Docket Item #6
BAR CASE# 2005-00078

BAR Meeting
June 22, 2005

ISSUE: Addition and alterations

LOCATION: 227 North West Street

Figure 1 - Rear elevation

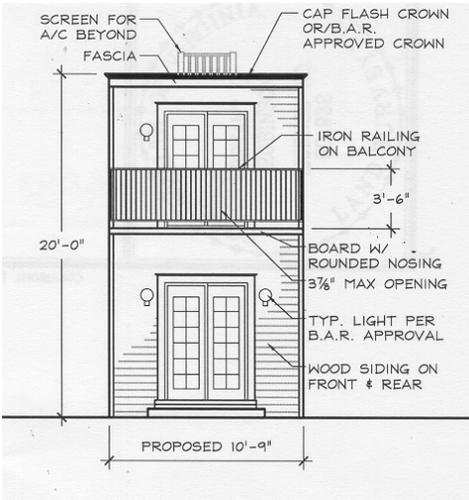
Rear Addition - A two story, flat roofed addition is proposed for the rear elevation. The addition will be 15'9" long, 10'9" wide and 20' high. The addition is smaller than the existing main block. It will extend several feet beyond the rear wall of one story addition to the north and will be roughly equal in length to the house to the south. It will be no higher than the existing house at the rear and 2 ½' lower than the house at the front. The addition will be 1'5" narrower than the existing house to avoid building on the area of deed overlap along the south property line and to assure that all drainage occurs on the subject property. Both side walls will be blind. The rear elevation has a pair of multi-light doors centered in the first and second stories. The doors will be wood doors with simulated divided lights manufactured by Kolbe and Kolbe. The second story will have a balcony across the full width of the addition. As drawn, the balcony has a simple railing with straight pickets. There will be two light fixtures on either side of the first story door and a single fixture beside the second story door. A cut sheet of the exterior light fixtures provided by the applicant shows a traditional lantern style fixture with a polished brass finish. Contrary to what is indicated on the drawings, the applicant has stated that the all sides of the addition will be clad with wood lap siding. The roof of the addition will be clad in single ply membrane and will not be visible. An HVAC unit will be located on the roof of the addition, close to the end of the existing house. The unit will be screened by a 24" high wood fence with 4 x 4 posts at the corners and 3" pickets with a 1" spacing. The applicant has affirmed the siding, doors, trim and HVAC screening will be painted.

Figure 4 - Front elevation

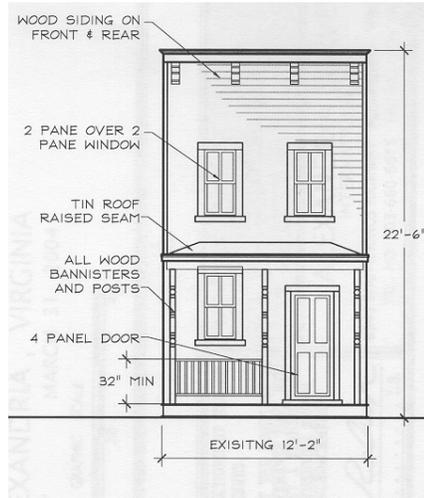
The existing house will be renovated and a new front porch will be added. The asphalt siding will be removed and replaced with wood lap siding. The existing non-historic front windows will be replaced with new Kolbe and Kolbe wood windows with a two-over-two configuration. The applicant has stated that the front windows will have true divided lights. The existing non-historic front door will be replaced with a new four panel wood door. Although not shown on the drawing, the applicant has confirmed that there will be an exterior light fixture beside the front door. The fixture will be the same brass lantern as used on the rear addition. Although the drawing shows the first story window raised above the top of the adjacent door, the applicant has confirmed to Staff that the existing window and door locations on the front elevation will be unchanged. Similarly, the applicant has confirmed that the existing historic cornice will be retained as is and that the drawing was not intended to depict any alteration to that feature. The meter box located on the front of the house will be moved to the side and recessed.

The new, one story porch will extend nearly the full width of the front of the house and project 4' from the front of the house. Although not shown on the drawings, the applicant has confirmed that the porch will be held back 6" on either end so as not to encroach on the deed overlap on the south side of the property. According to the applicant, the porch will have a brick foundation with wood flooring. It will have a hip roof covered in standing seam metal and supported by turned wood posts. The railing will be a simple wood railing with straight pickets. The applicant has affirmed that the new siding, windows, door, trim and wood porch will be painted.
